Appendix I
Responses to IDEQ
And
EPA Comments

IDEQ Technical Review Comments on the Draft Five-Year Review Document for the Naval Reactors Facility Inactive Landfill Areas, Operable Units 8-5/8-6 – December 28, 2000

EPA REVIEW OF 11/14/00 DRAFT FIVE-YEAR REVIEW DOCUMENT FOR THE NAVAL REACTORS FACILITY INACTIVE LANDFILL AREAS – December 28, 2000

Not in Color (see text for colored version)
 Figure 2 Suspected Location of Current and Historical Perched Water Zones at NRF

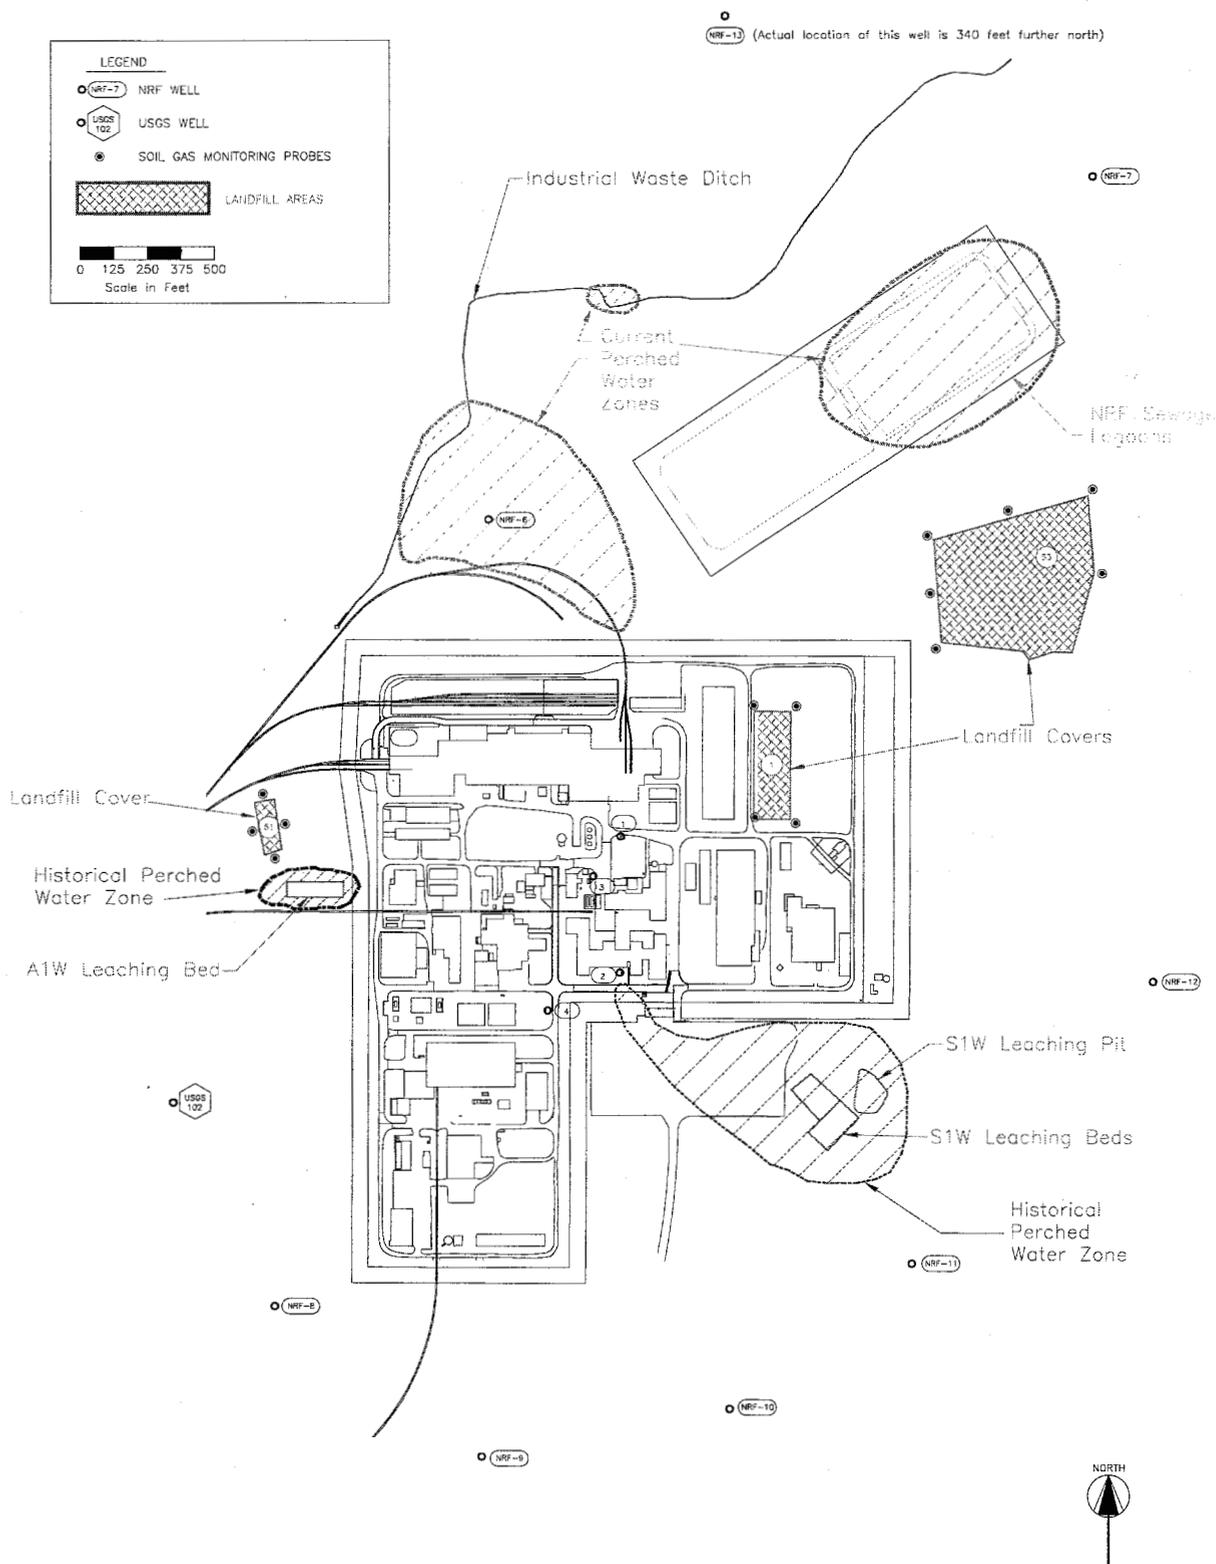
Please identify the estimated locations of perched water beneath the NRF. Having this information would be helpful in interpreting the 5 year review monitoring data.

The text will be changed as follows: “...Perched water, which lies above the regional water table approximately 100 feet below land surface, occurs in several locations at NRF including beneath the IWD, the sewage lagoons, and historically the leaching beds/pits. In general, perched water forms at any location where a substantial surface recharge is present....” The following sentence will be added to the end of this paragraph: “Figure 2 shows the suspected locations of current and historical perched water zones.” This figure is attached at the end of NRF comment responses.
